**PROJECT: MIDDLE SCHOOL MEDIA CENTER RENOVATIONS
AL STANBACK MS, GRAVELLY HILL MS, ORANGE MS**

CRA PROJECT #: 2601.01, 2601.02, 2601.03

DATE: 4/1/2026

MODIFICATIONS TO THE CONTRACT DOCUMENTS FOR THE ABOVE-NAMED PROJECT SHALL BE MADE AS DESCRIBED BELOW AND SHALL BE INCLUDED IN THE BID AMOUNTS:

A101

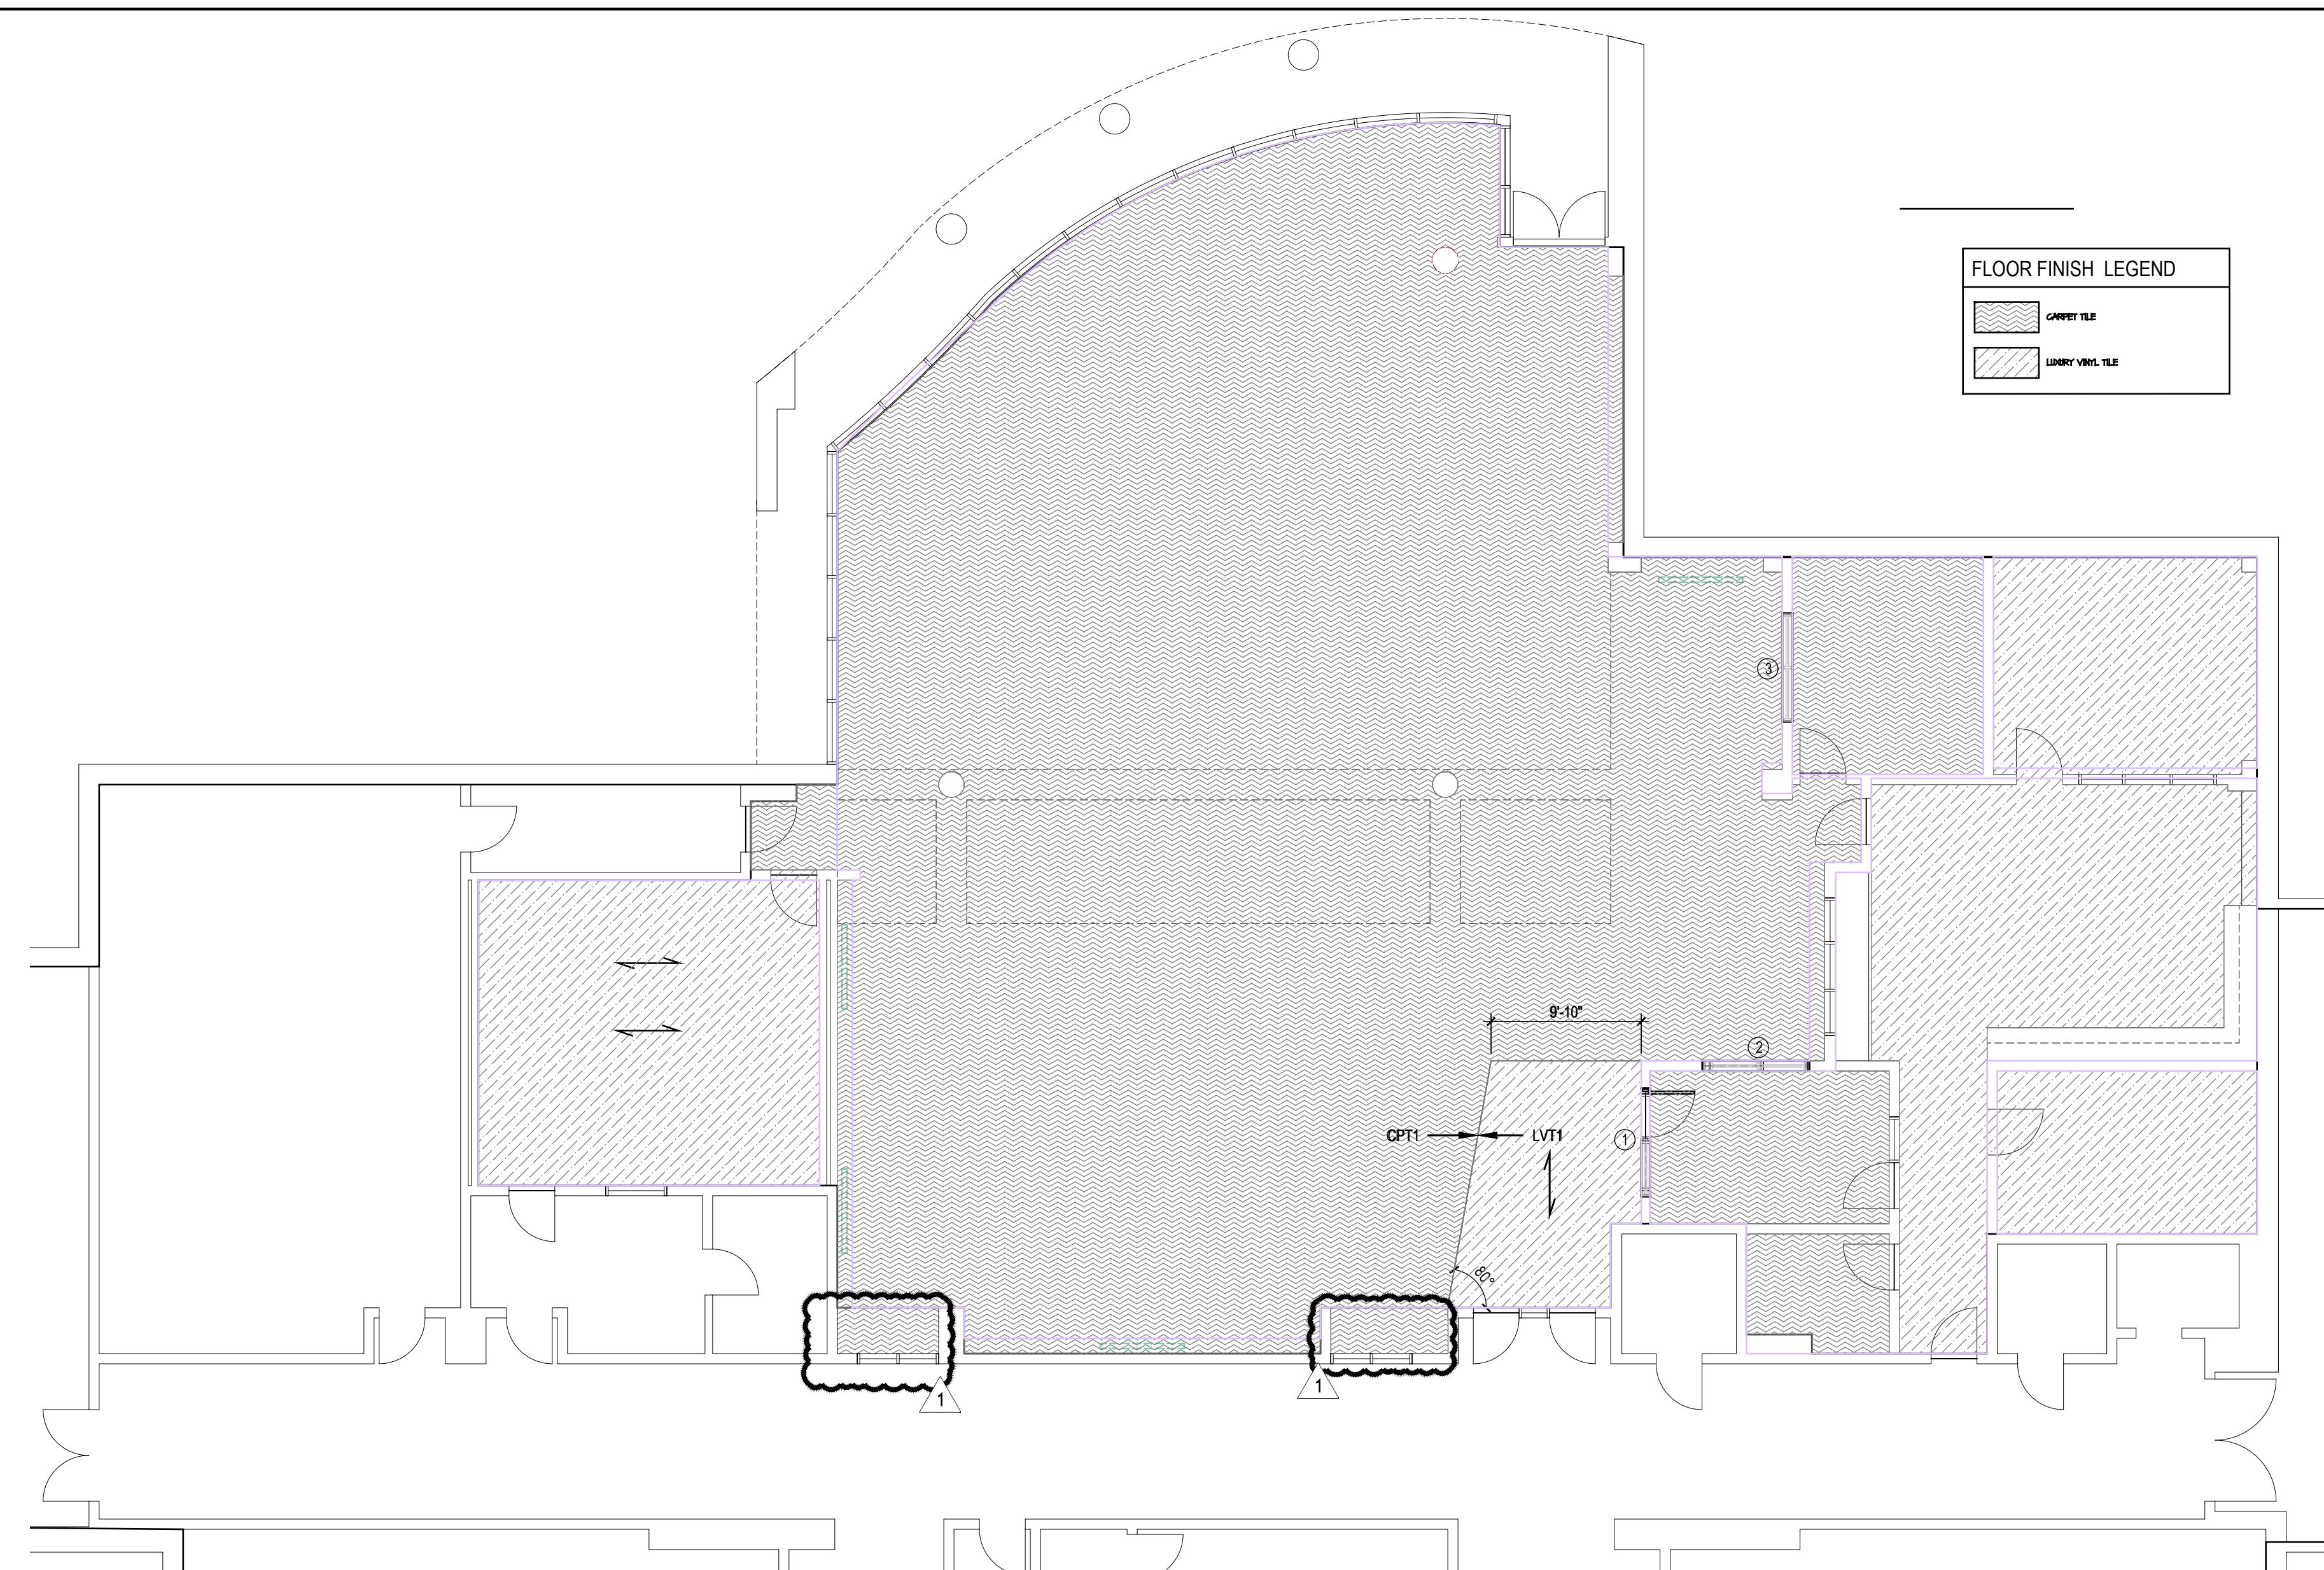
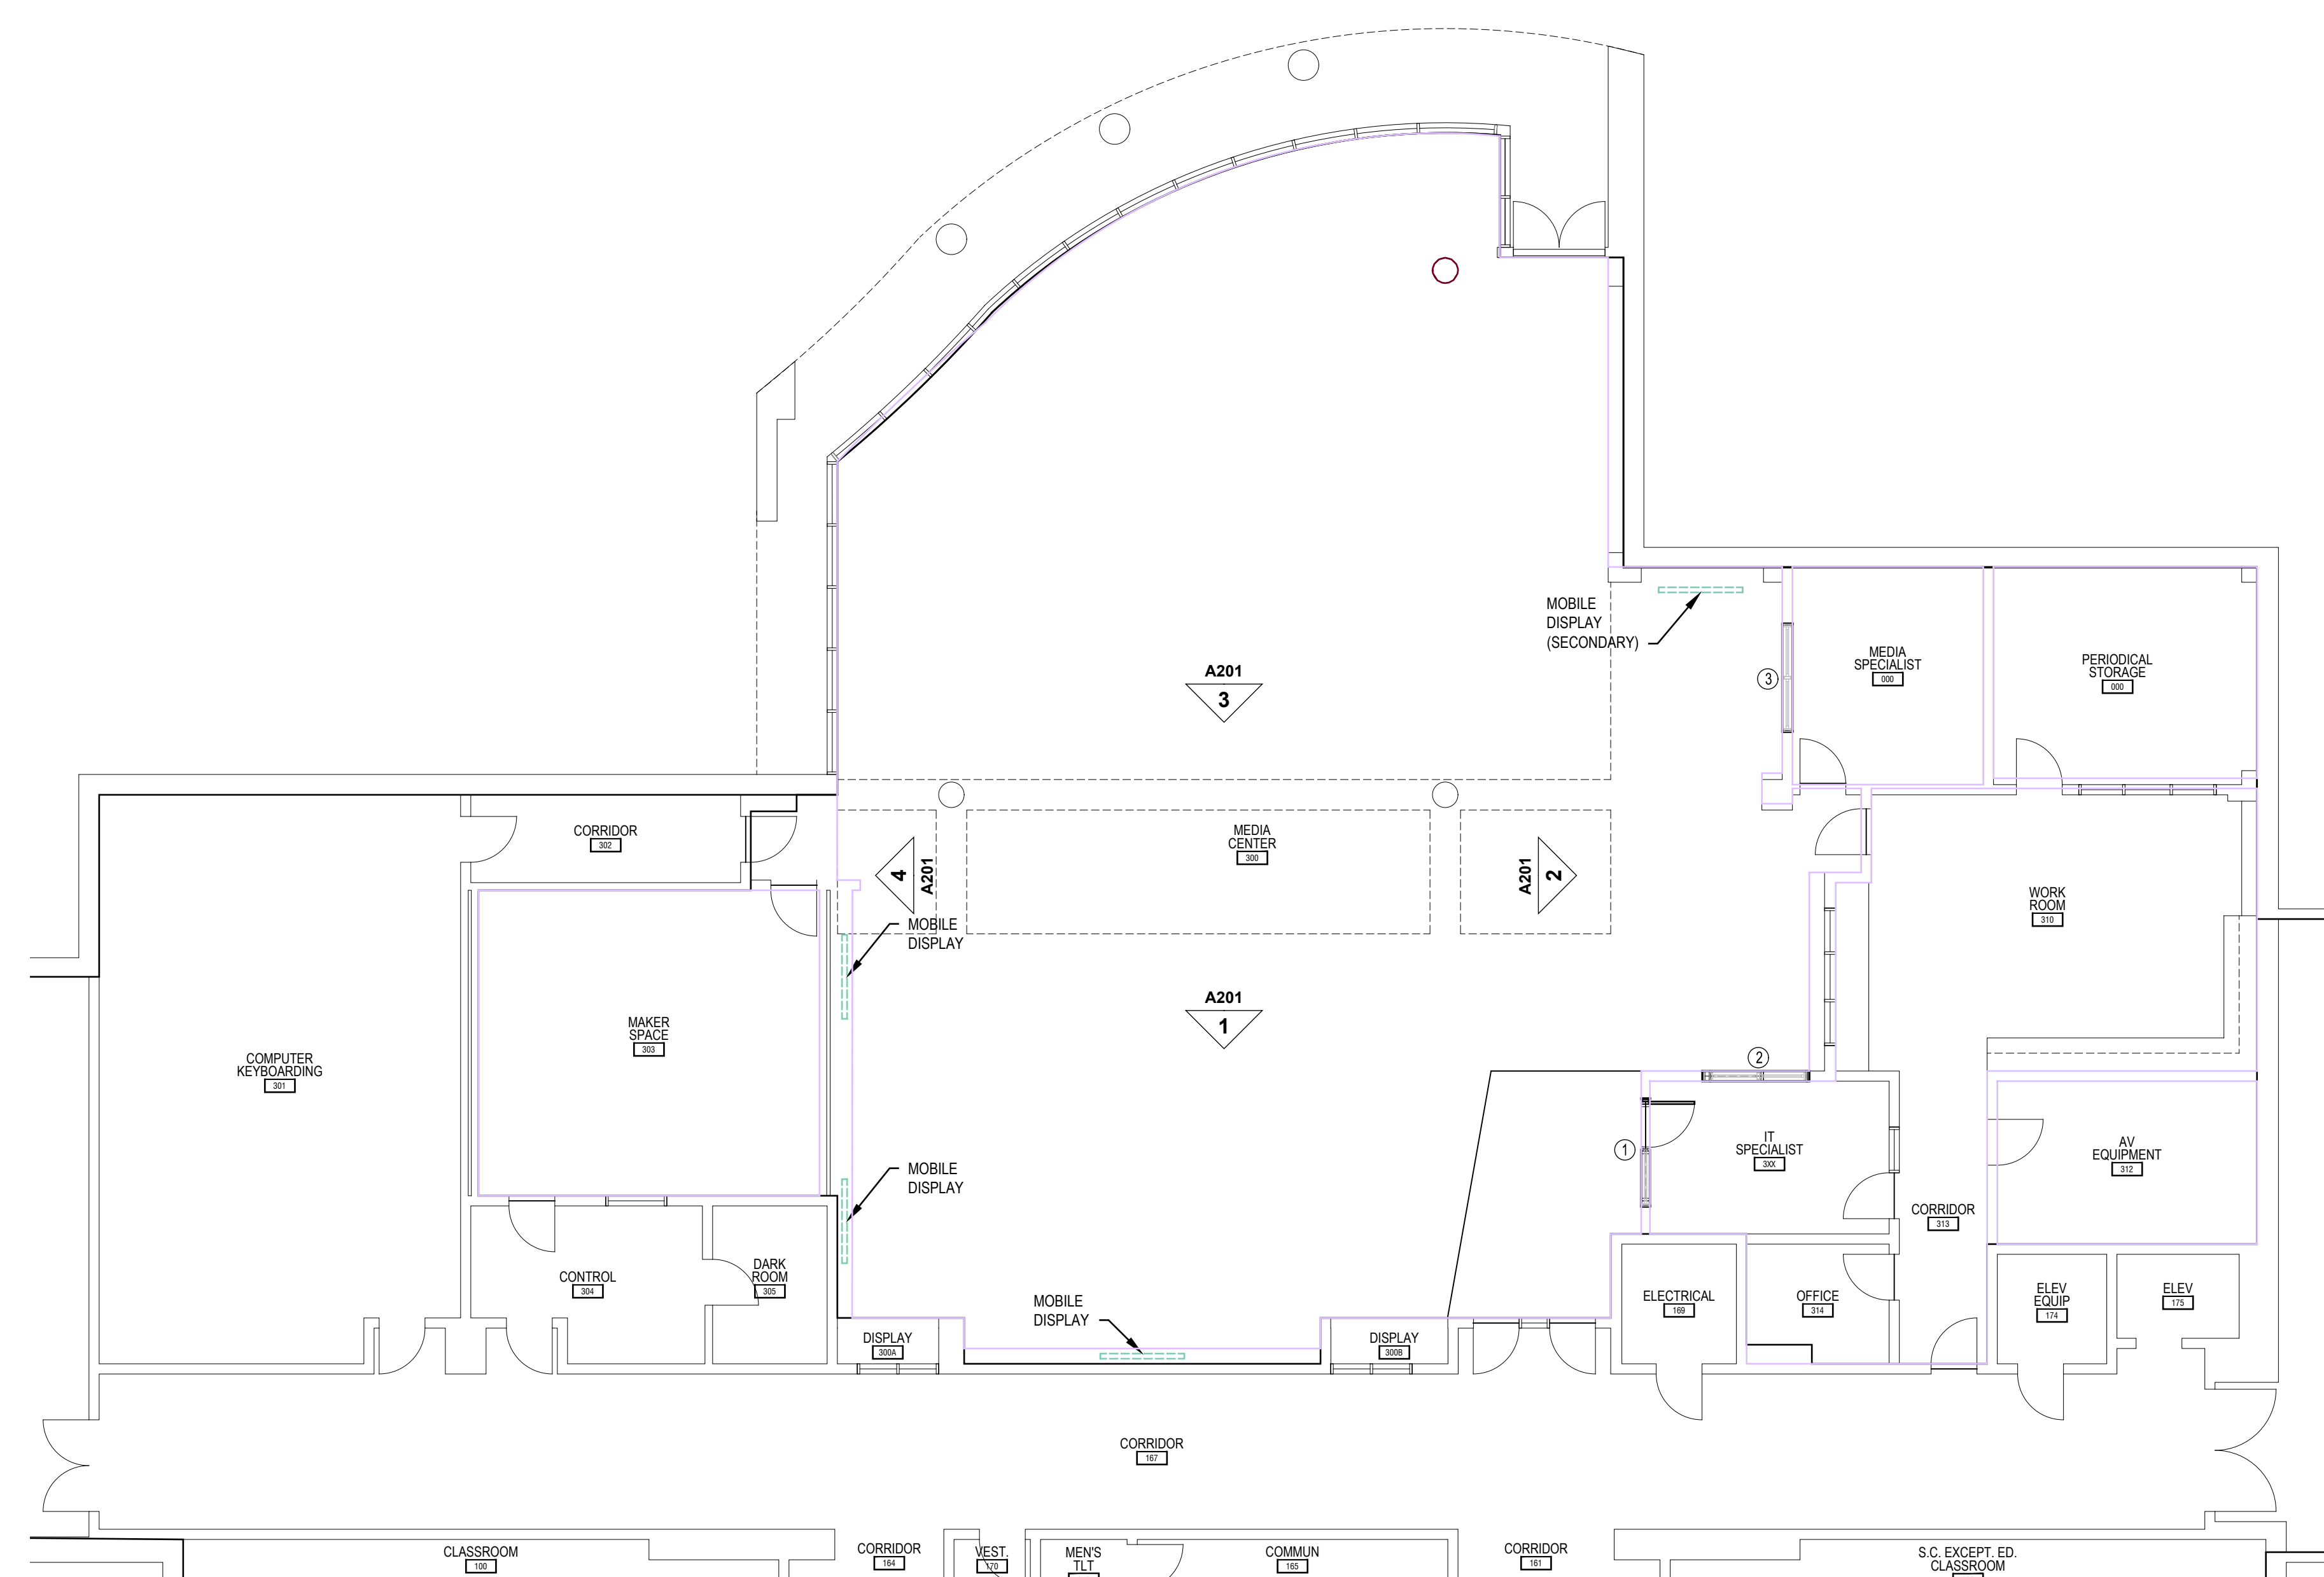
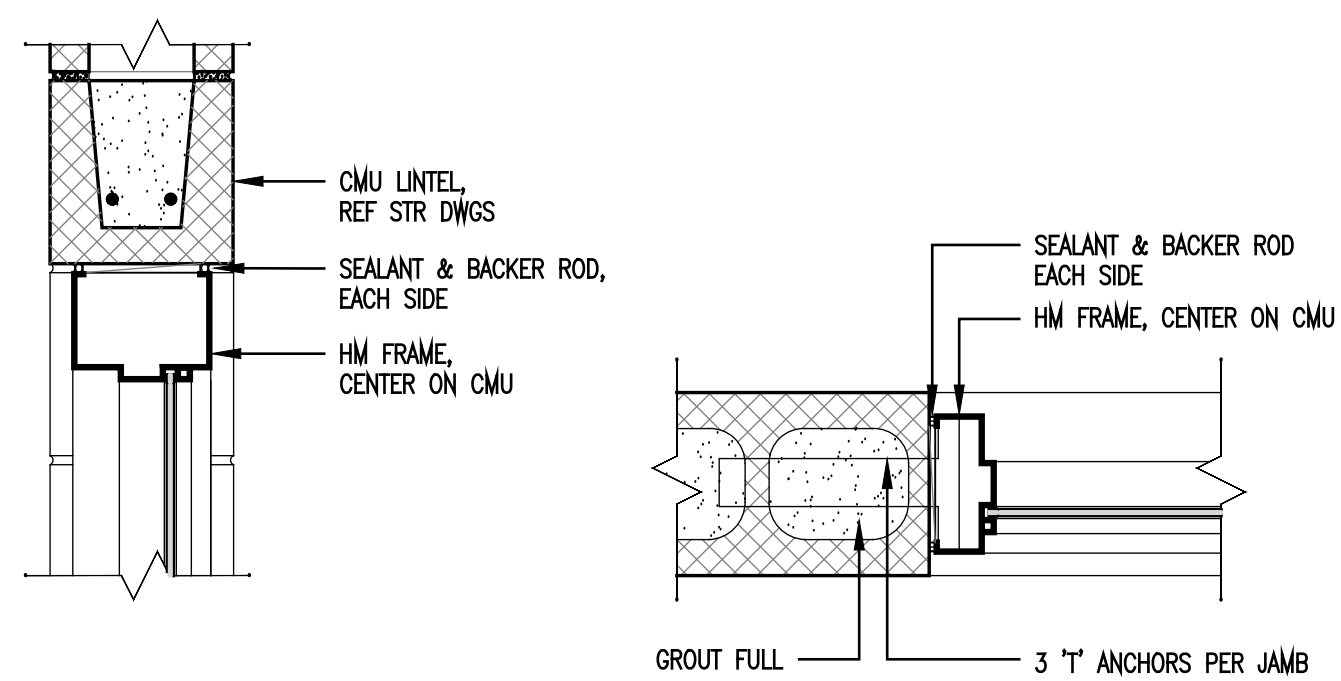
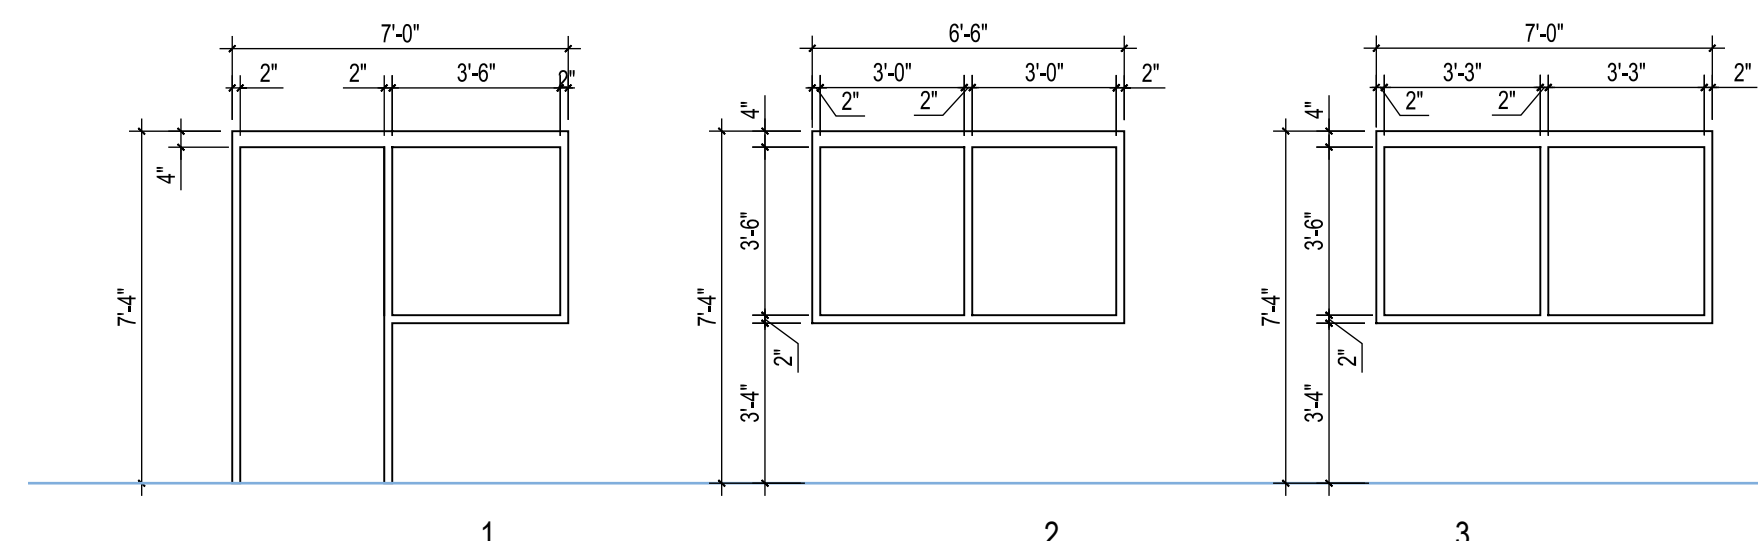
20. Contractor is responsible for removal of fixed shelving.
21. Partitions surrounding the new IT Specialist office were noted to be metal stud with GWB, in lieu of masonry as noted in the drawings.
